SYDNEY WESTERN CITY PLANNING PANEL

COUNCIL ASSESSMENT REPORT

Panel Reference	PPSSWC-173.
DA Number	DA-42/2021
LGA	Liverpool City Council
Proposed Development	Proposed demolition of existing buildings and structures, construction and operation of a seniors housing development involving 116 room residential care facility in a three-storey building over a basement, together with associated facilities, access, and landscaping under State Environmental planning Policy (Housing for Seniors or People with a Disability) 2004
Street Address	173 Elizabeth Drive and 18 Woodlands Road, Liverpool Lot 3 DP 651870 and Lot E DP 36731
Applicant/Owner	Higgins Planning Pty Ltd / Wohl Investments Pty Ltd
Date of DA lodgement	13/01/2021
Number of Submissions	2
Recommendation	Refusal
Regional Development Criteria (Schedule 7 of the SEPP (State and Regional Development))	The development has a CIV of \$30,821,598.00 (excluding GST), pursuant to Clause 2 of Schedule 6 State Environmental Planning Policy (Planning Systems) 2021.

Figure 4: Part South Elevation fronting Elizabeth Drive

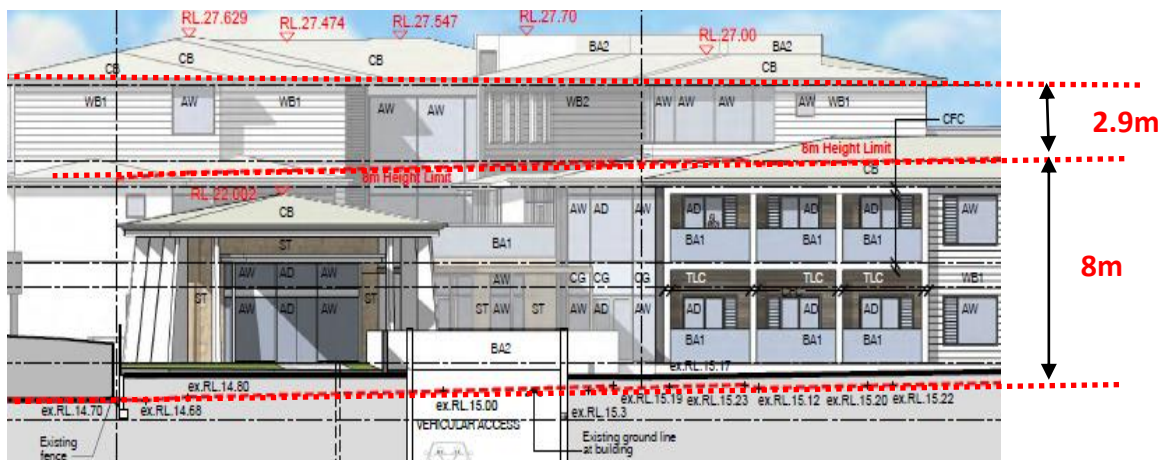
The full extent of the ceiling breach is shown on Figure 4 below. The proposed ceiling height of the top most floor is RL 25.9 being approximately 10.9m to the ceiling, a variation of 2.9m. This represents a variation of some 36% to the ceiling of the top most floor or an entire level adding another 18 units into the development.

The increased floor level and breach of the maximum ceiling height is confined to the western part of the building and relies on the adjoining approved 3 to 5 story mixed use development. However, the increased building height will impact on the amenity (overlooking) of the existing single storey dwellings along Elizabeth Drive. Likewise the dwellings to the north will be impacted on the increase ceiling height which is crafted for a two storey structure.
